Denman Island Local Trust Committee Regular Meeting Agenda

Denman Island Local Trust Committee Minutes of Regular Meeting

**Re: Development Permit Application – Lot A, Section 23, Denman Island,
Nanaimo District, Plan VIP74719**

TITLE
SITE PLAN

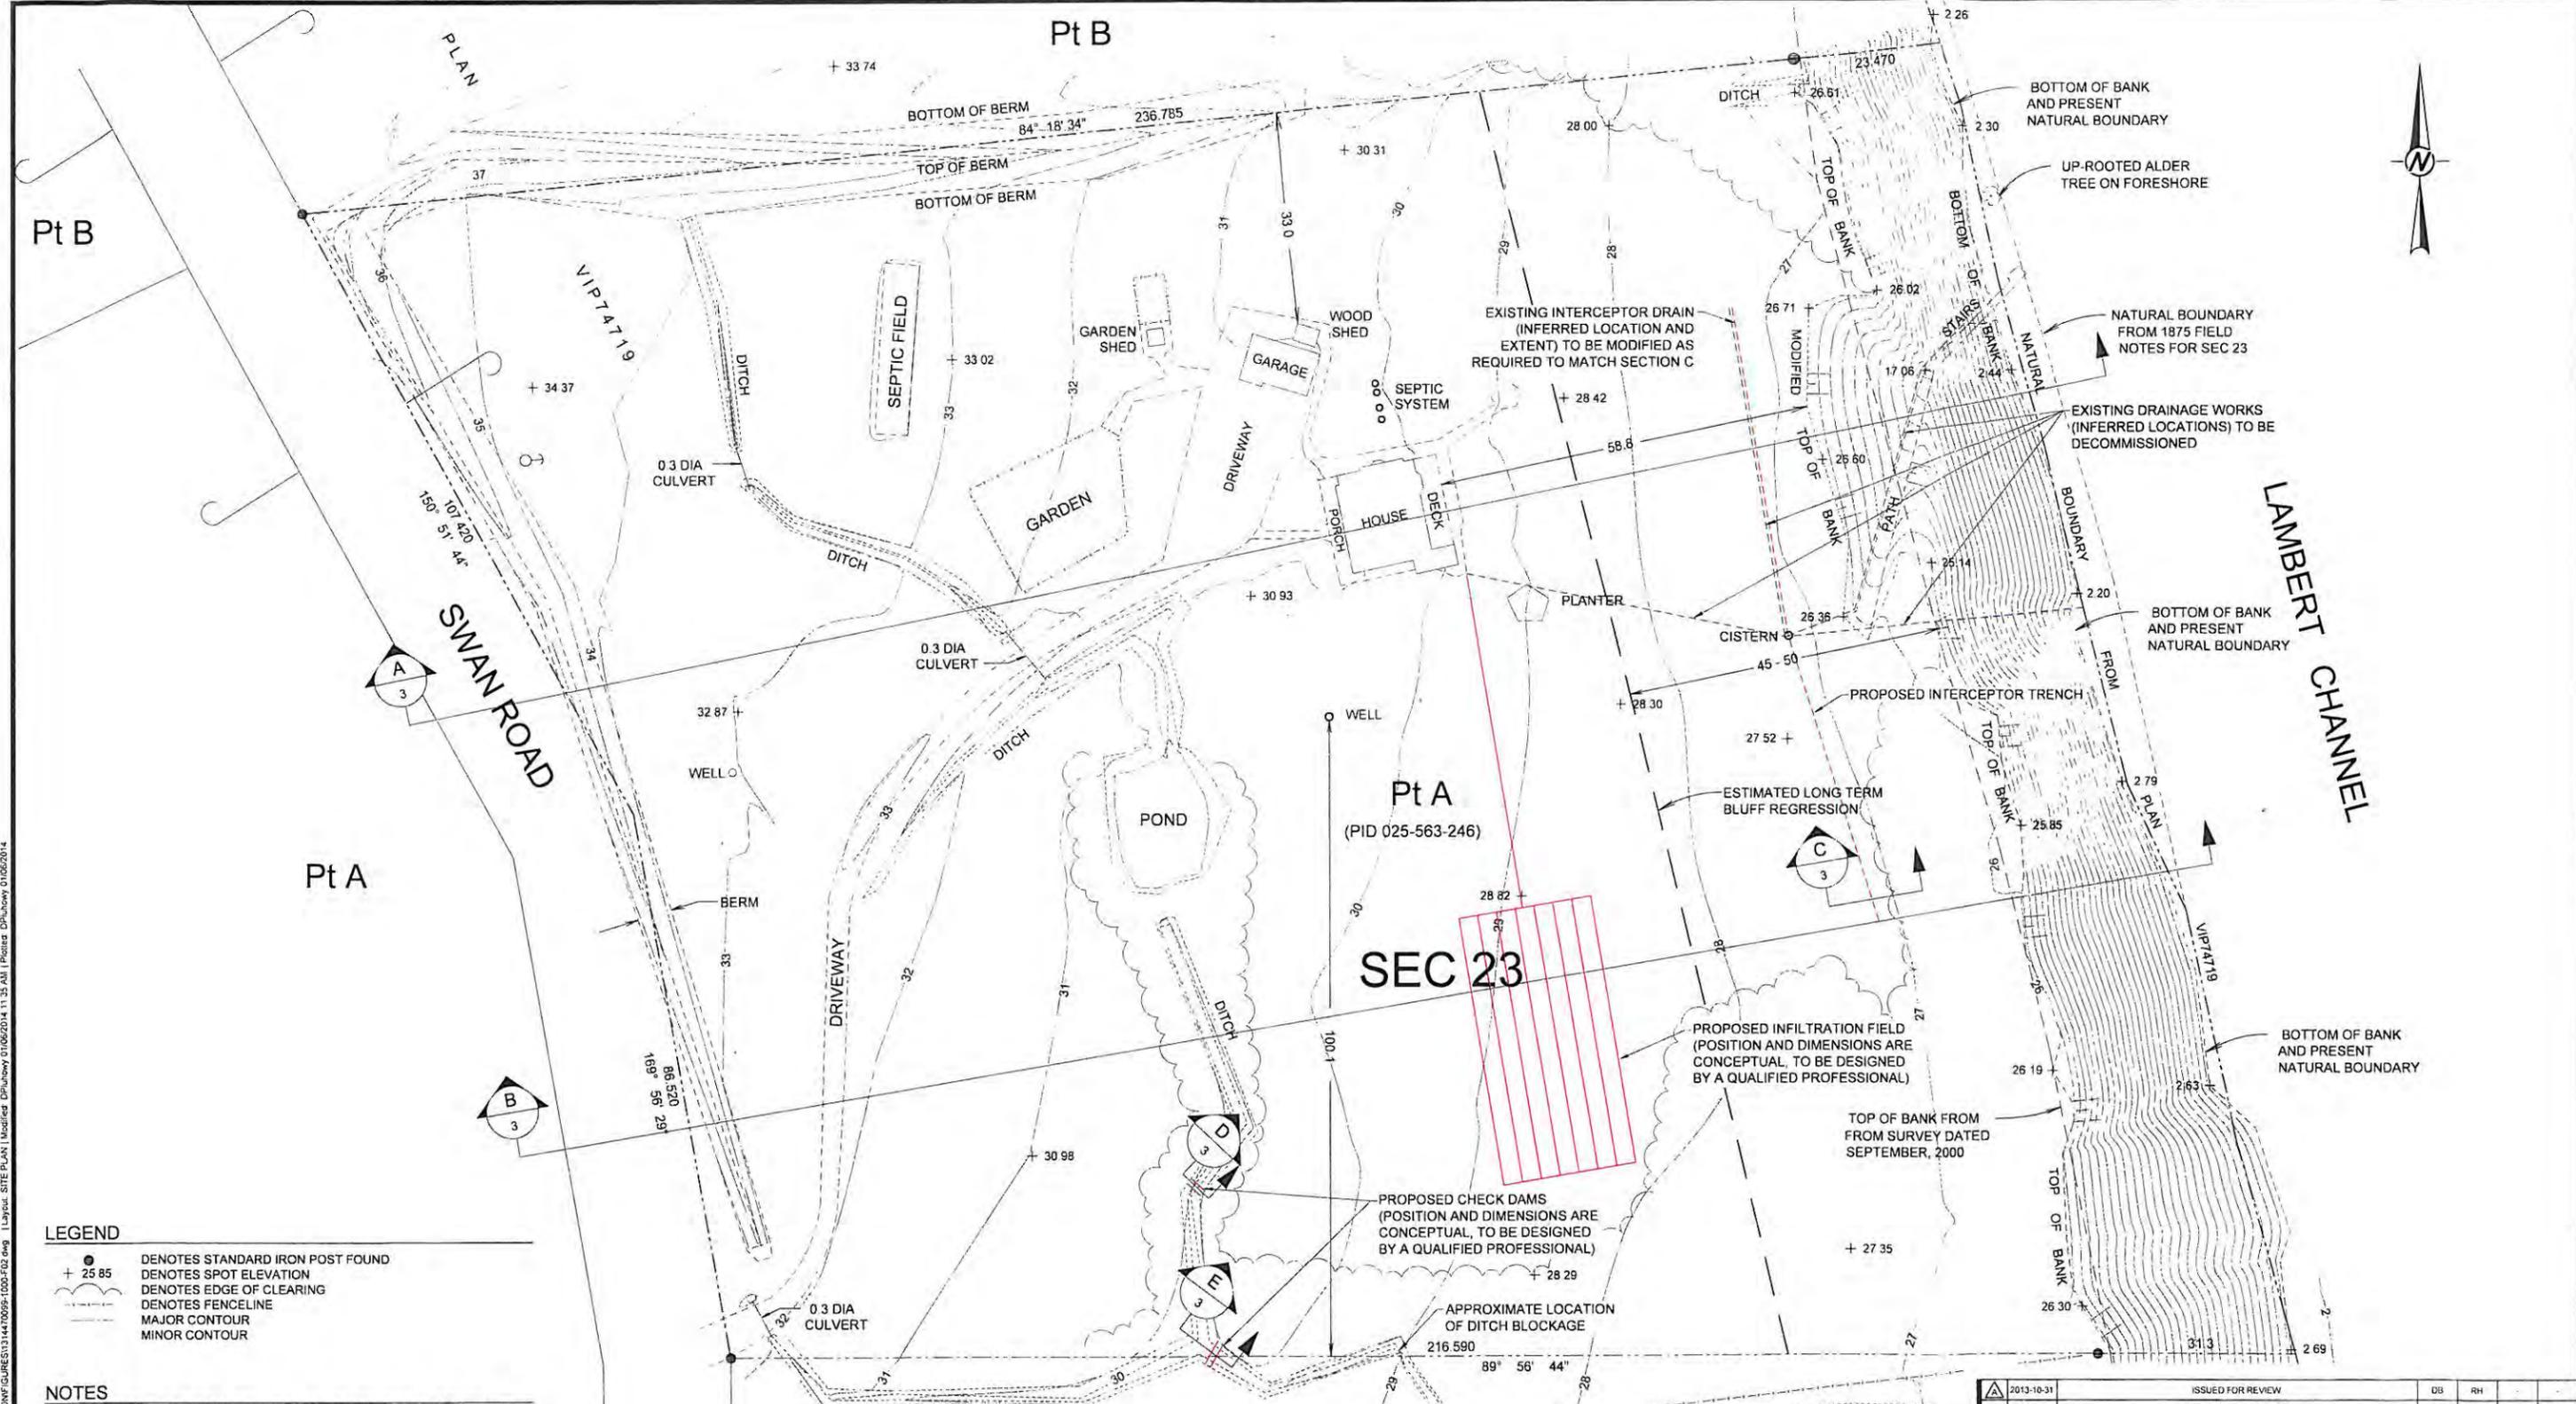
regular inspection and maintenance of the existing drainage network of corrugated plastic pipes which extends over the escarpment are not considered viable in the long term. In order to provide long term water management on the site it is recommended that the network of corrugated plastic drainage pipes directed towards and extending onto and down the bluff slopes be decommissioned as shown in Figure 2.

- (d) The network of corrugated plastic drainage pipes directed towards and extending onto and down the bluff slopes shall be decommissioned as recommended at 6.2 and shown on Figure 2 of the Golder Associates on or before August 15, 2015.

SCALE A **A** TYPICAL CROSS-SECTION
2

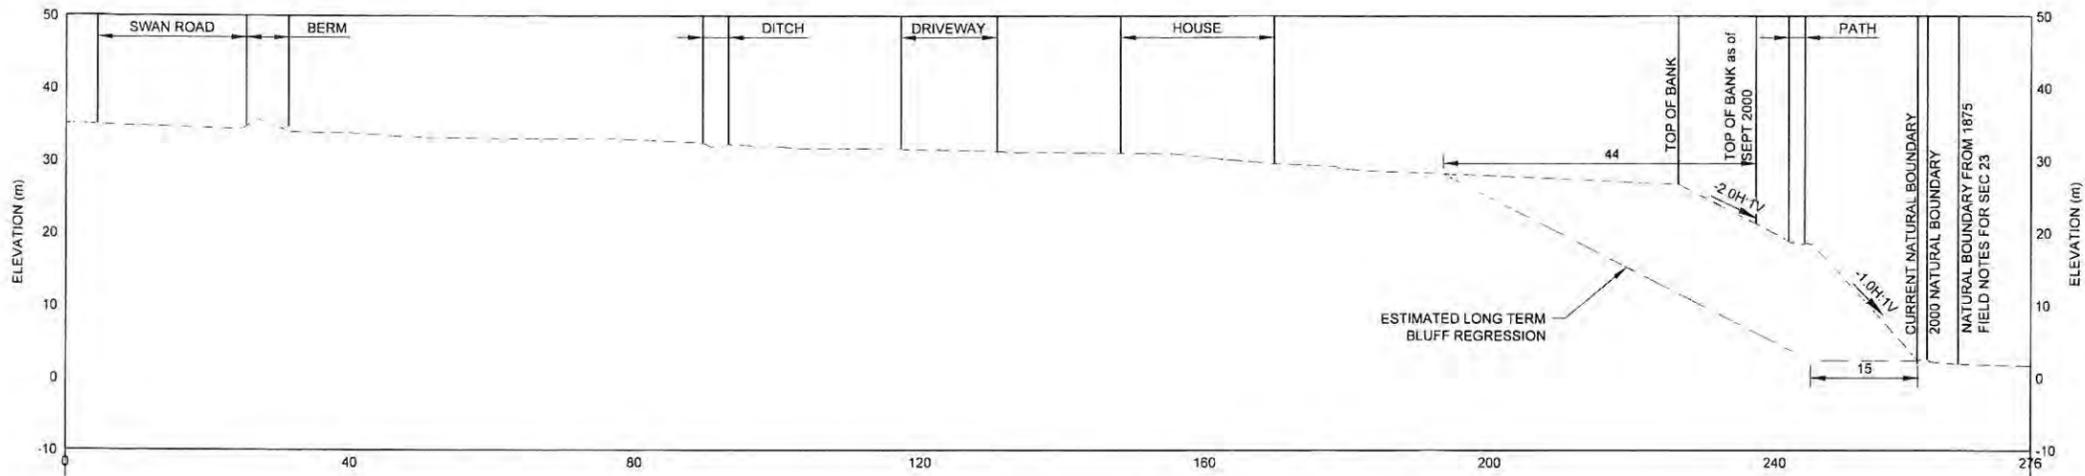
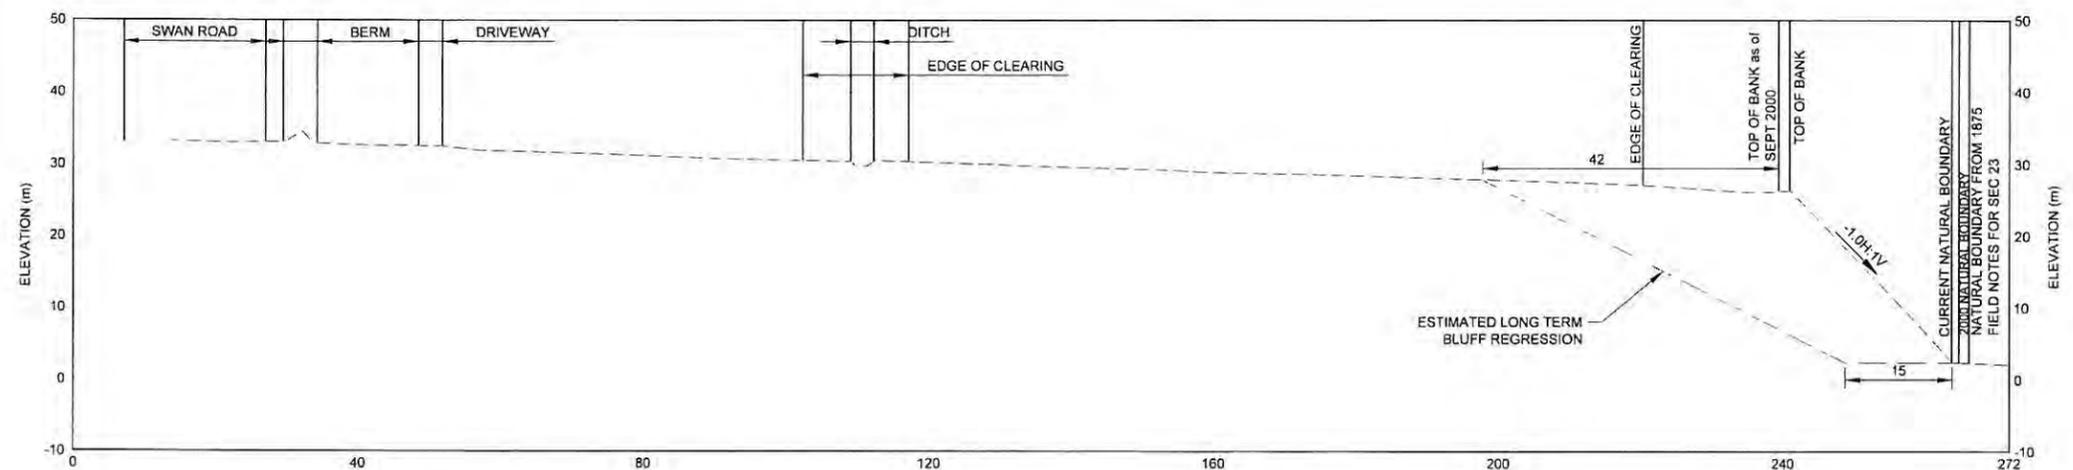
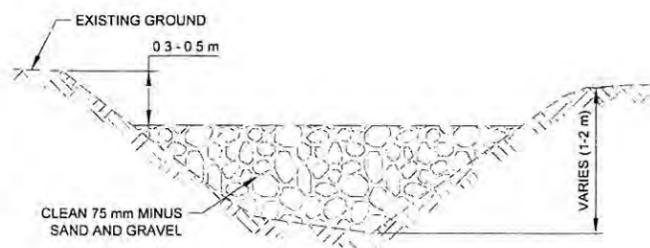
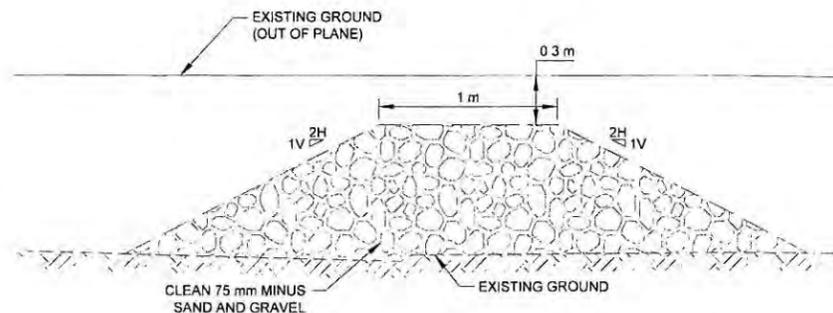
As illustrated on the cross sections presented in Figure 3, the setback of the existing residence, garage, and septic system from the current crest of the bluff slopes is located approximately 15 m beyond an allowance for a 15 m of long term toe regression as well as a 2 Horizontal to 1 Vertical overall long term stable bluff slope, provided that the recommended remediation and mitigative measures are implemented.
